**Re: 700-712 Union Street (Primrose School)  
Site Plan and Special Permit Review Update**

BETA Group, Inc. (BETA) has reviewed documents for the project entitled: **Primrose School** located at 700-712 Union Street in Franklin, MA. This letter is provided to update BETA's findings, comments and recommendations.

- Existing Conditions Survey
- Plans (17 sheets) entitled: **Site Plan Set for Primrose School Franchising Company Proposed Child Day Care Facility** June 22, 2022, revised 9/23/2022, prepared by Stonefield Engineering & Design, LLC. of Salem, MA.

**FIGURE 2**  
**2022 Existing Traffic**  
**Volumes**

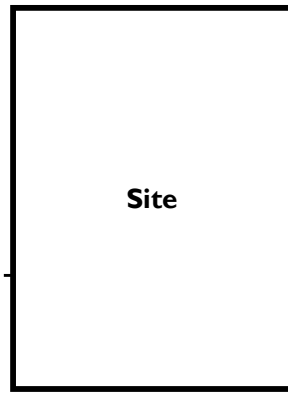
STONEFIELD: The directional volumes and calculations contained within the Crash Intersection Worksheet were revised to be consistent with the 2022 Existing Traffic Volumes illustrated in Figure 2 within the revised Traffic Impact Assessment prepared by Stonefield.

BETA2: Information provided. No further comment.

**TRAFFIC SIGNAL TIMING DIRECTIVE**

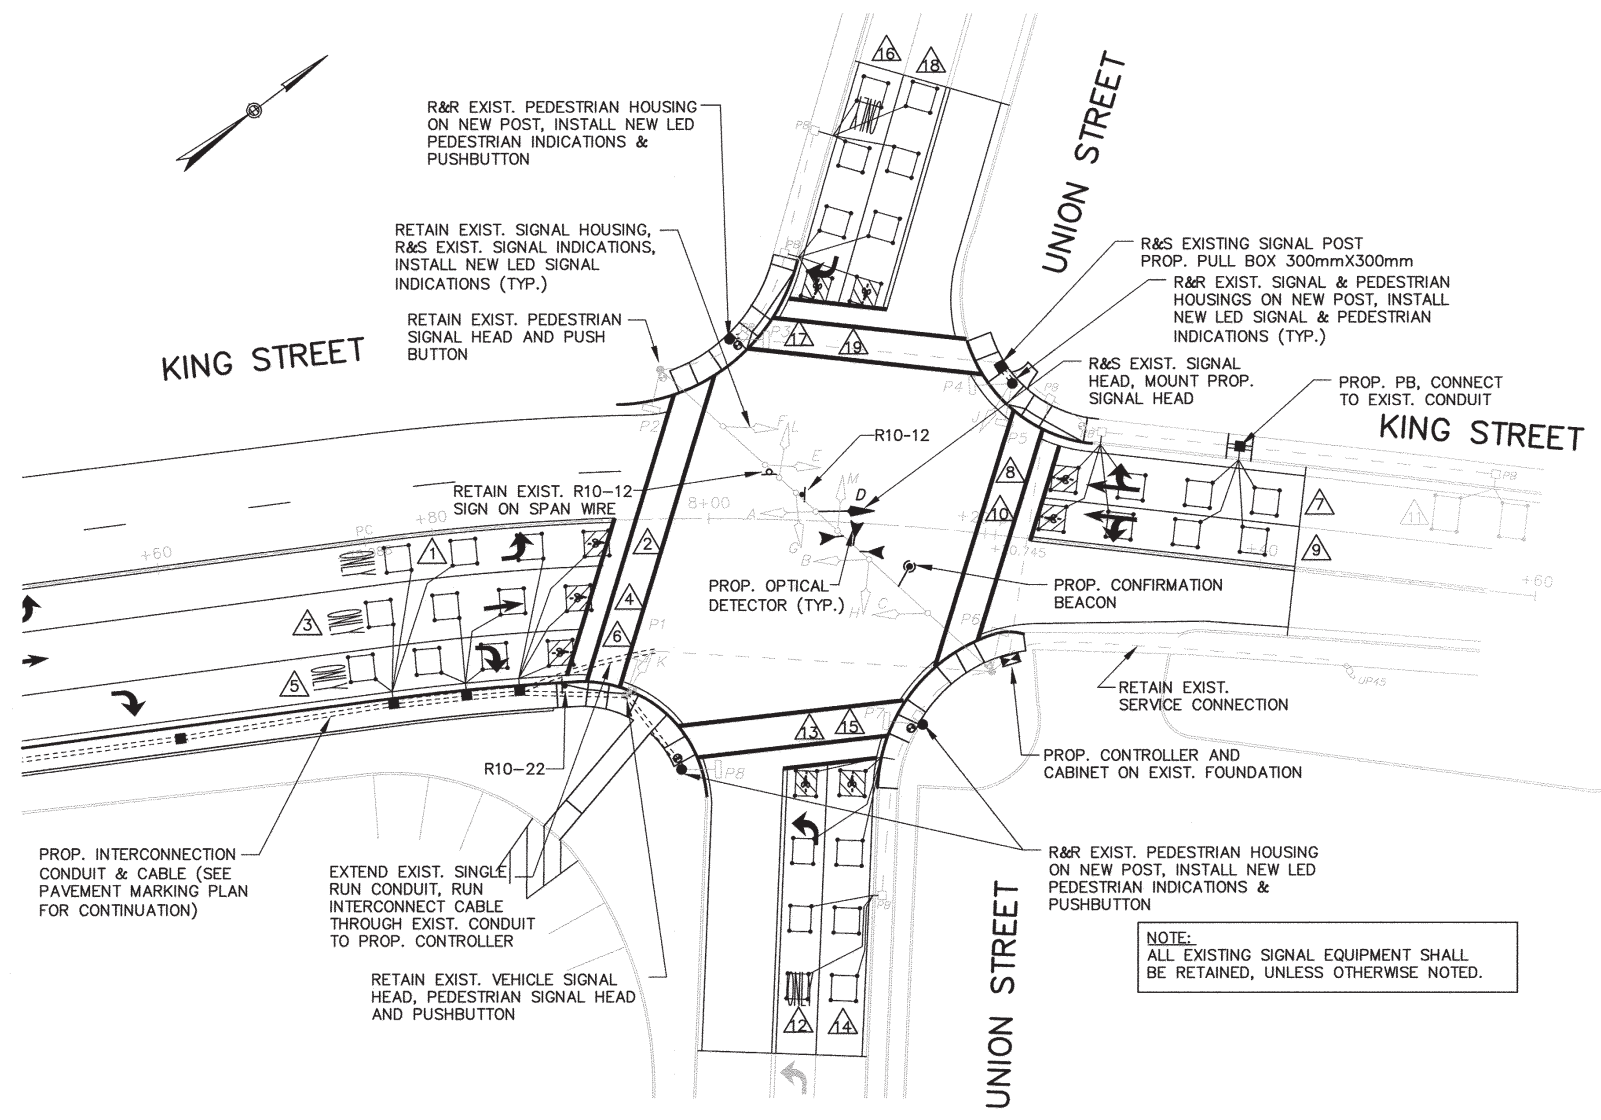
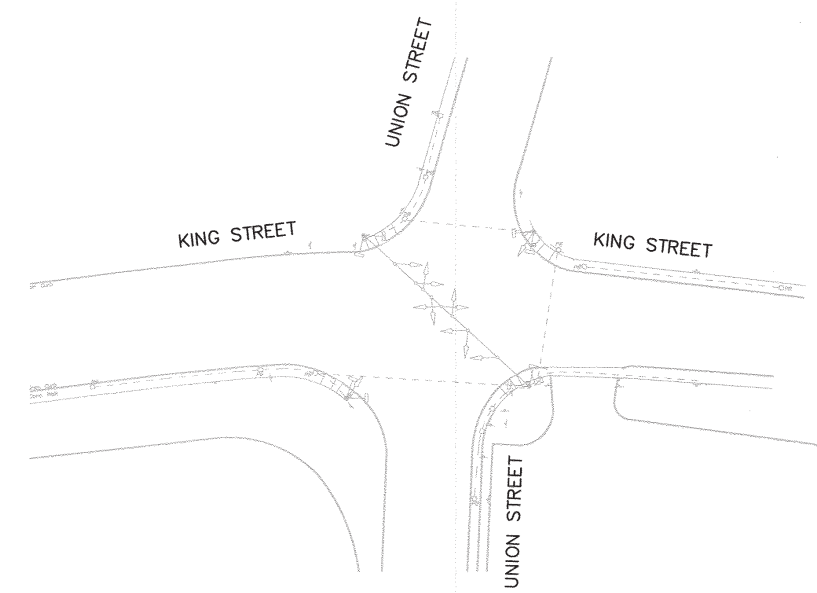
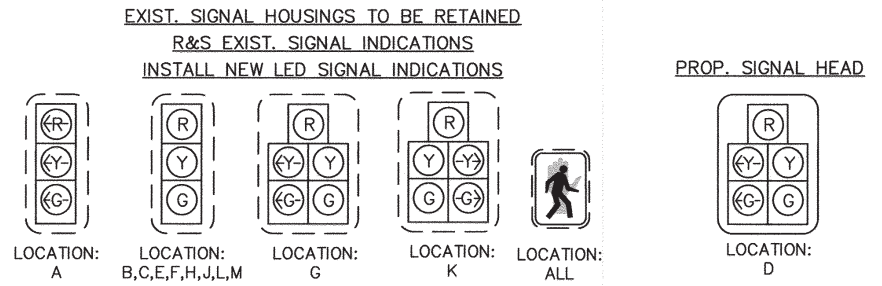
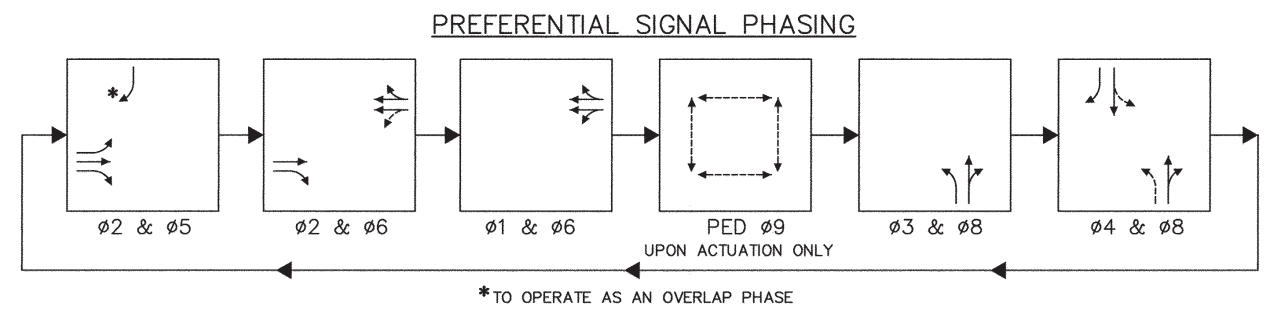
- T2. The timing directives mentioned in the report are missing from the Appendix. Provide the information for reference.

STONEFIELD: Traffic Signal Plans provided by MassDOT pertaining to the study intersection of King Street and Union Street utilized for analysis purposes are contained within the Technical Appendix of the Traffic Impact Assessment prepared by Stonefield.

BETA2: Information provided. No further comment.
